Dentistry — Coupling dimensions for handpiece connectors

AMENDMENT 1

Dentistry — Coupling dimensions for handpiece connectors

AMENDMENT 1

Figure 6

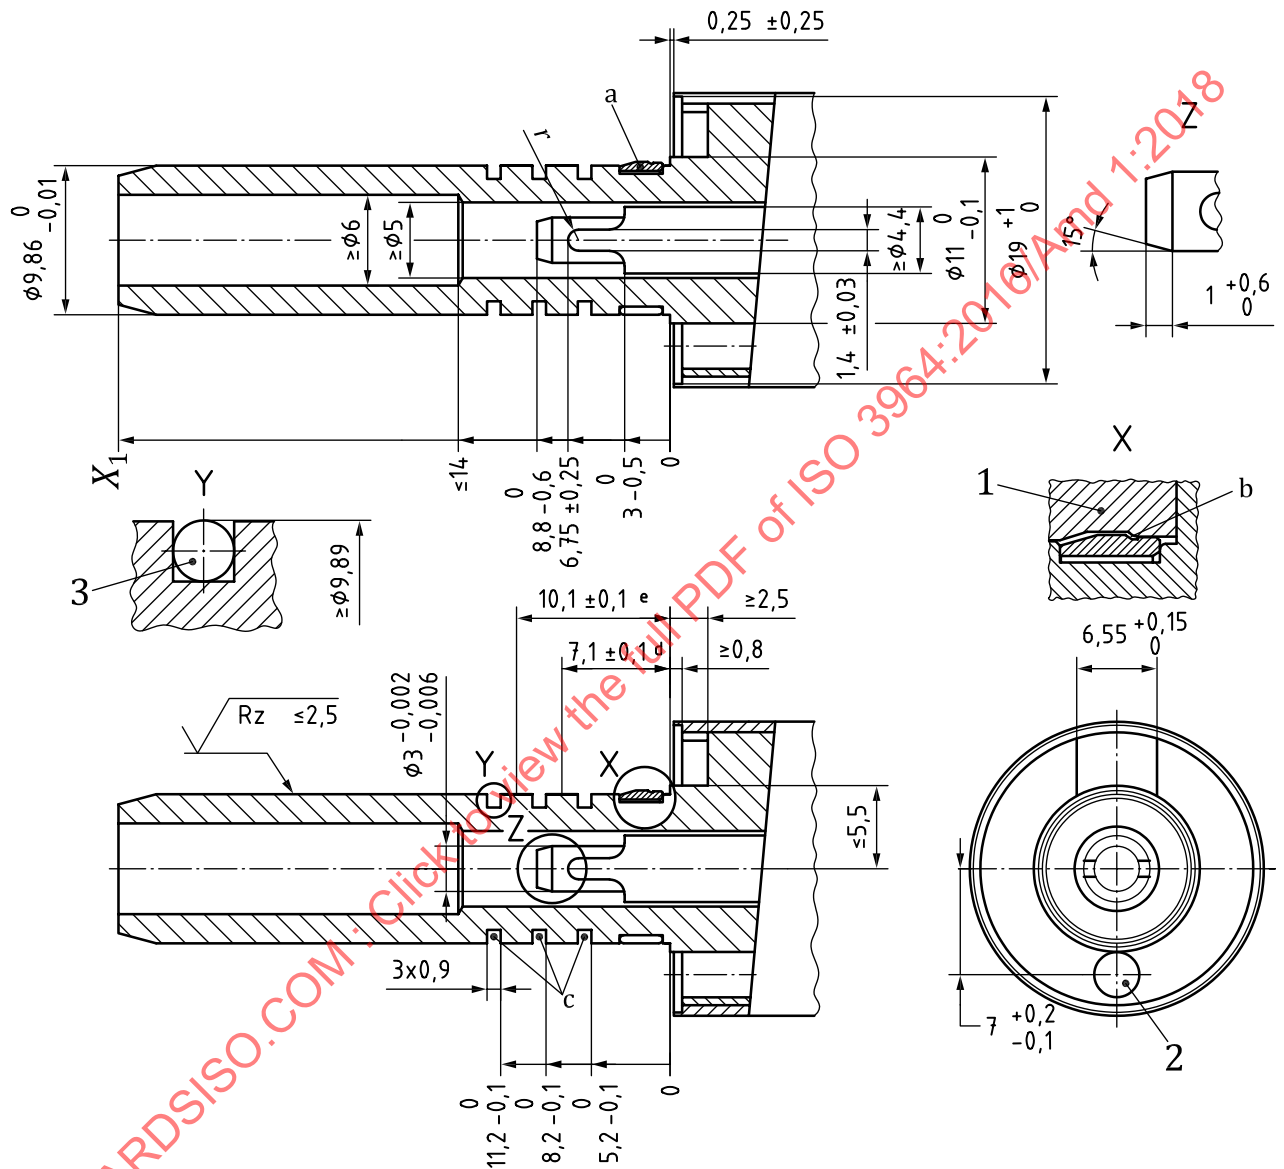
Correct error in the upper and lower part of drawing, left section, right side for the motor body.

Replace Figure 6 with the following Figure:
